Contract #: 04-0120F4Cty: SF/ALA Rte: 80 PM: 13.2/13.9File #: 69.28**WELDING INSPECTION REPORT****Resident Engineer:** Siegenthaler, Peter**Address:** 333 Burma Road**City:** Oakland, CA 94607**Report No:** WIR-018953**Date Inspected:** 09-Dec-2010**Project Name:** SAS Superstructure**OSM Arrival Time:** 700**Prime Contractor:** American Bridge/Fluor Enterprises, a JV**OSM Departure Time:** 1900**Contractor:** Zhenhua Port Machinery Company, Ltd (ZPMC), Changxing Island **Location:** Shanghai, China**CWI Name:** Xu Le Feng**CWI Present:** Yes No**Inspected CWI report:** Yes No N/A**Rod Oven in Use:** Yes No N/A**Electrode to specification:** Yes No N/A**Weld Procedures Followed:** Yes No N/A**Qualified Welders:** Yes No N/A**Verified Joint Fit-up:** Yes No N/A**Approved Drawings:** Yes No N/A**Approved WPS:** Yes No N/A**Delayed / Cancelled:** Yes No N/A**Bridge No:** 34-0006**Component:** TOWER Components**Summary of Items Observed:**

WEST TOWER LIFT-5

WELDING INSPECTION REPORT

NORTH TOWER LIFT-5

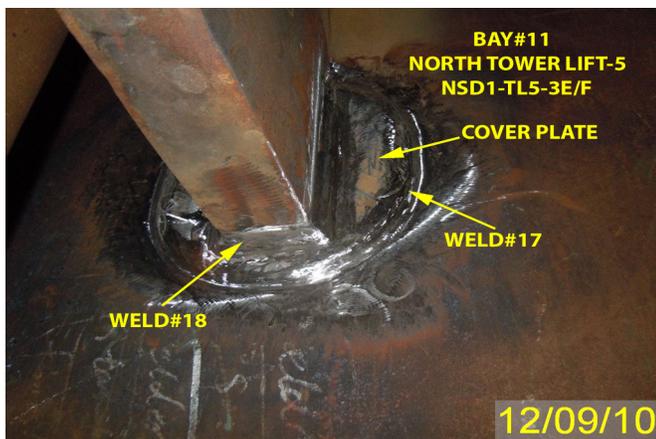
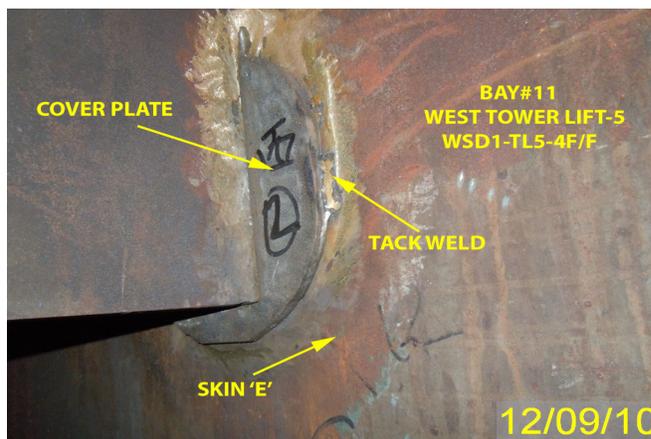
During the Caltrans Quality Assurance (QA) in-process observation on North tower lift-5 Cover plate, this QA Inspector discovered the following issue:

- ZPMC fabrication personnel removed 2 cover plates including a total four (4) Non-SPCM fillet welds without engineer notification.
- And re-welded with new cover plates, where the dimension of the cover plate does not comply with the approved drawings.
- As per the shop drawing the required length of the cover plate is 151.4 mm.
- But the length measured to be approximately 212 mm.
- Welds are fillet welds joining cover plate to skin 'E'.
- The weld designations are NSD1-TL5-3E/F#01; 02; 17; 18.
- This component located at fabrication Bay#11.

AWS D1.5 2002 Section 3.7.5: "The Engineer shall be notified before improperly fitted and welded members are cut apart".
